## Product Change Notification / SYST-03GWYJ923

ERRATA - dsPIC33EVXXXGM00X/10X Family Silicon Errata and Data Sheet Clarification Errata Document Revision

- Updates silicon issue 24 (Flash).
- Adds silicon issue 49 (Oscillator).
- Adds data sheet clarification 1 (DMTCON (Deadman Timer Control Register)).

## dsPIC33EVXXXGM00X/10X Family Silicon Errata and Data Sheet Clarification

FIGURE 1:

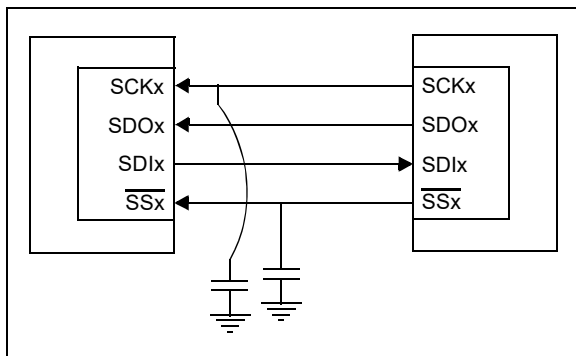
When the SPIx module is configured in SPIx Slave mode (MSTEN bit (SPIxCON1[5]) = 0), the frame slave (FRMEN bit (SPIxCON2[15]) = 1) and the SPIFSD bit (SPIxCON2[14] = 1), in Standard Buffer mode with the Clock Polarity Select bit, CKP = 0, the data are not transmitted in both 8-bit and 16-bit mode, but the data are being received correctly.

Adding a capacitance on the signal, as shown in Figure 1, will help the data to be received properly.

**FIGURE 2: TIMING DIAGRAMS FOR CENTER-ALIGNED AND EDGE-ALIGNED MODES**

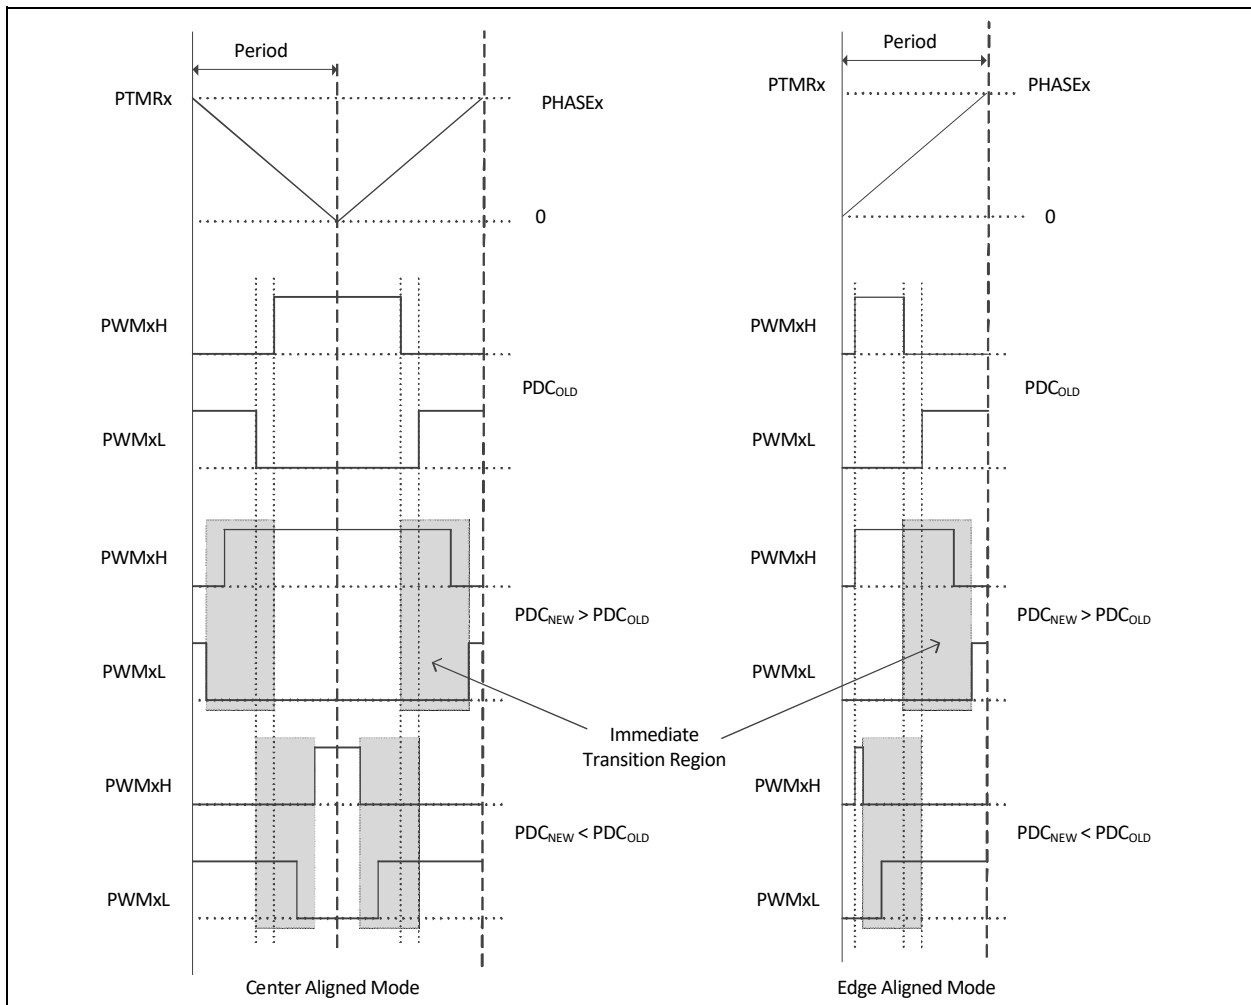
The PWM generator may not assert dead time on the edges of transitions. This has been observed when all of the following conditions are present:

In [Figure 2](#), if the duty cycle write occurred in the shaded box, then PWMxH and PWMxL will make an immediate transition without dead time.

However, in most applications, the duty cycle update timing can be controlled using the TRIGx trigger or Special Event Trigger, such that the above mentioned conditions are avoided altogether.

**FIGURE 3: ILLUSTRATION OF 1 TOSC GLITCH WHEN PWM OVERRIDE IS TURNED OFF**

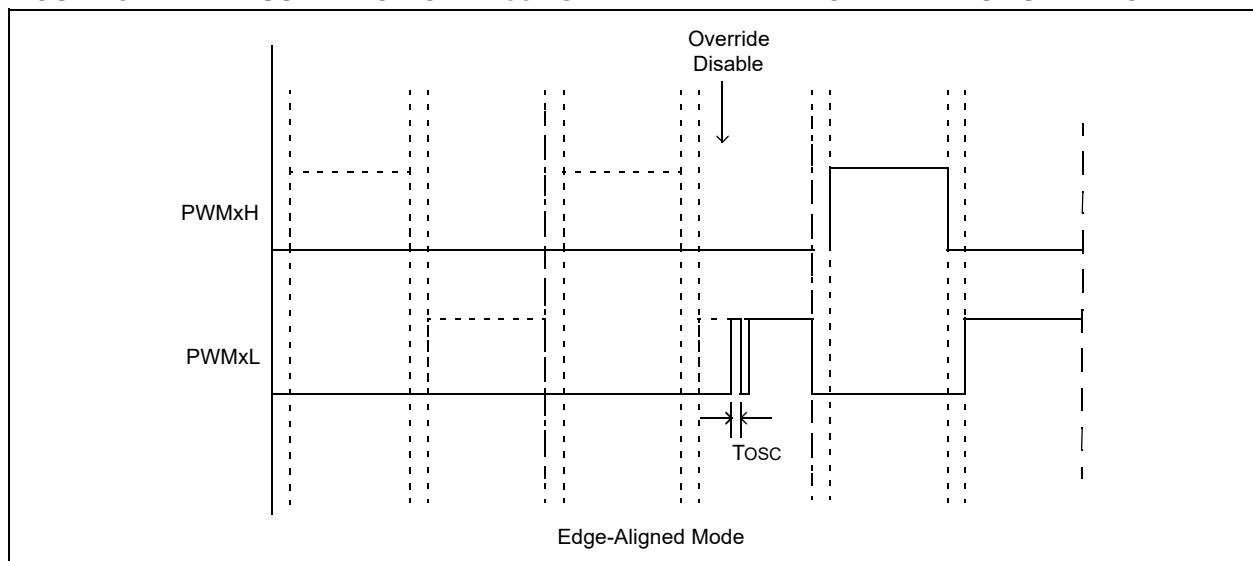
In Complementary mode after the PWM module is enabled (PTEN = 1), if the PWM override is turned off, a one TOSC glitch will be present on the rising edge of either the PWMxH or PWMxL pins, whichever occurs first, as shown in Figure 3.

The glitch will be present on PWMxH/PWMxL every time the override state is changed from override enabled to override disabled. The width of this glitch is equal to one TOSC when PCLKDIV[2:0] (PTCON2[2:0]) = 000. Increasing the PWMx input clock prescaler setting will increase the width of the glitch accordingly.

FIGURE 4:

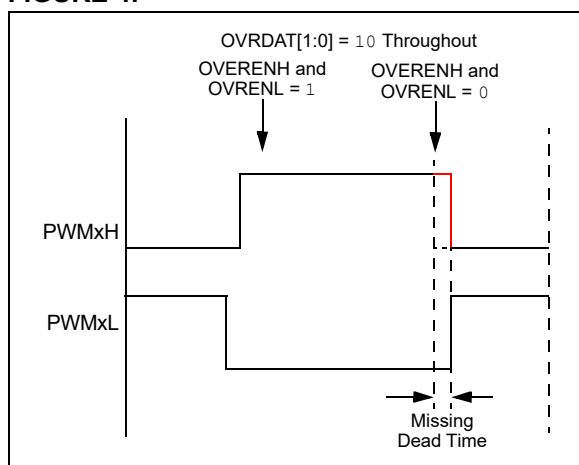
In Complementary Output mode, the expected dead time between transitions of the PWMxH and PWMxL outputs may not be asserted when the following occurs:

- Output override synchronization is configured to occur on the CPU clock boundary (IOCONx[0] = 0);
- Both PWMxH and PWMxL overrides are enabled prior to the event (OVRENH and OVRENL are both '1'), and
- Both overrides are disabled (OVRENH and OVRENL are both '0') at the instant the dead time should be asserted (Figure 4). This has been observed in both Center-Aligned and Edge-Aligned modes.

FIGURE 5:

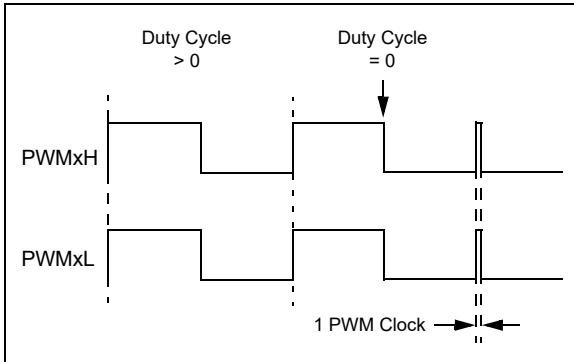
In the Redundant Output mode (IOCONx[11:10] = 10) and Push-Pull Output mode (IOCONx[11:10] = 01) with Immediate Update disabled (PWMCONx[0] = 0), when the Duty Cycle register is updated from a non-zero value to zero, a glitch pulse of a width equal to one PWM clock will appear at the next PWM period boundary, as shown in Figure 5, for the Redundant Output mode. Here, the Duty Cycle register refers to the PDCx register if PWMCONx[8] = 0 or the MDC register if PWMCONx[8] = 1.

If the application requires a zero duty cycle output, there are two possible work around methods:

1. Use the PWM override feature to override the PWM output to a low state instead of writing to the Duty Cycle register. In order to switch back to a non-zero duty cycle output, turn off the PWM override. The override-on and override-off events must be timed close to the PWM period boundary if the IOCONx register has been configured with IOCON[0] = 0 (i.e., output overrides via the OVDDAT[1:0] bits occur on the next CPU clock boundary).

2. Enable the Immediate Update (PWMCONx[0] = 1) while configuring the PWM module, i.e., before enabling the PWM module (PTCON[15] = 1). With Immediate Update enabled, writes to the Duty Cycle register can have an immediate effect on the PWM output. Hence, duty cycle write operations must be timed close to the PWM period boundary in order to avoid distortions in the PWM output.

**FIGURE 6:**

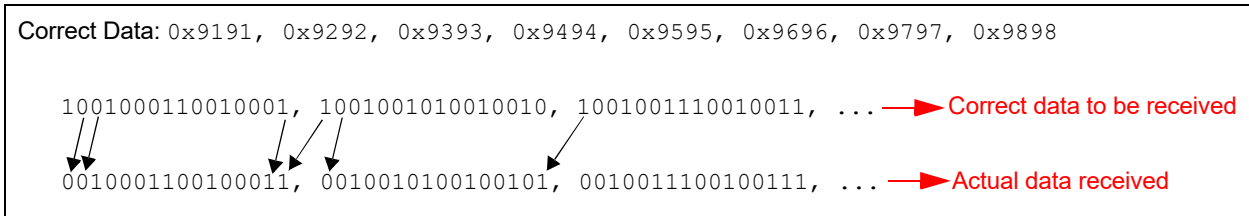
1. When the SPI is configured as master (MSTEN = 1), frame sync pulse input (SPIFSD = 1), enhanced buffer (SPIBEN = 1), CKP = 1, SMP = 1, FRMPOL = 1, FRMDLY = 1.
2. When the SPI is configured as master (MSTEN = 1), frame sync pulse input (SPIFSD = 1), enhanced buffer (SPIBEN = 1), CKP = 1, SMP = 1, FRMPOL = 0, FRMDLY = 0.

For example, the correct data that should be received are 0x9191, 0x9292, 0x9393, 0x9494, 0x9595, 0x9696, 0x9797, 0x9898, but the actual data received are 0x2323, 0x2525, 0x2727, 0x2929, 0x2B2B, 0x2D2D, 0x2F2F, 0x3130 (Figure 6).

**FIGURE 7: SIMPLIFIED BEHAVIOR**

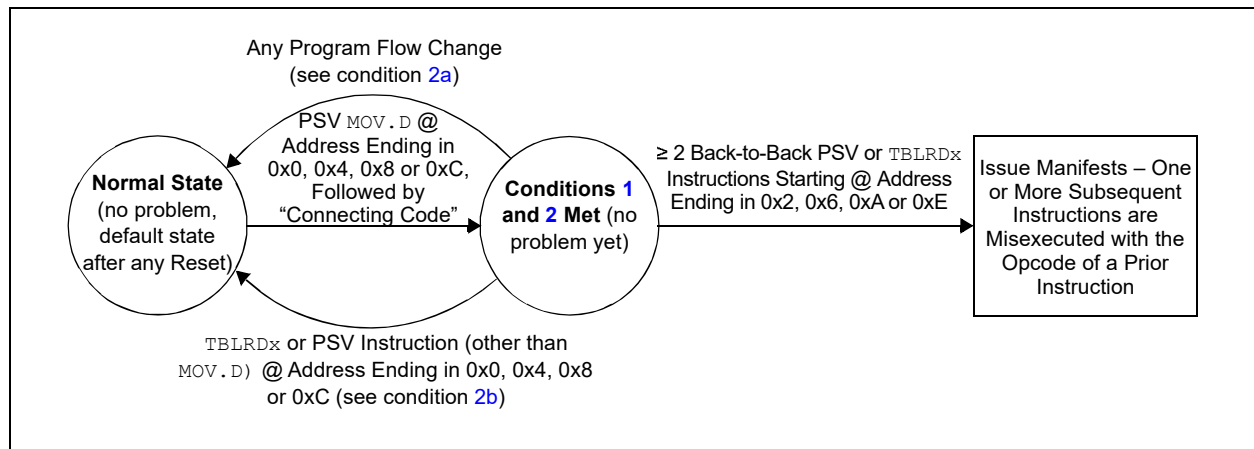
3.	≥ 2 back-to-back PSV or <code>TBLRDx</code> instructions are executed (following the code of condition 2), where the first of the back-to-back instructions is located at an address ending in 0x2, 0x6, 0xA or 0xE.

[Figure 7](#) provides an example of the effective behavior.

1. All instances of PSV `MOV.D` can be replaced with two PSV `MOV` instructions instead. Non-PSV `MOV.D` instructions acting on RAM/SFRs do not need to be modified; or
2. If not already present, a program flow change instruction (such as `BRA $+2`) can be inserted above back-to-back data Flash read sequences; or
3. Back-to-back data Flash read instruction sequences can be broken up by inserting a non-Flash read instruction (such as a `NOP`), in between the Flash read instructions; or
4. The alignment of the code can be shifted to avoid the required opcode location addresses.

C code built with MPLAB<sup>®</sup> XC16 Compiler Version 1.32, or later, implements the work around by default. However, if the application uses Assembly language routines, these should be manually modified to implement the work around. Additionally, if precompiled libraries are used, these should be built with XC16 Version 1.32 or later. For additional information, please visit: [www.microchip.com/erratum\\_psrds\\_psrds](http://www.microchip.com/erratum_psrds_psrds)
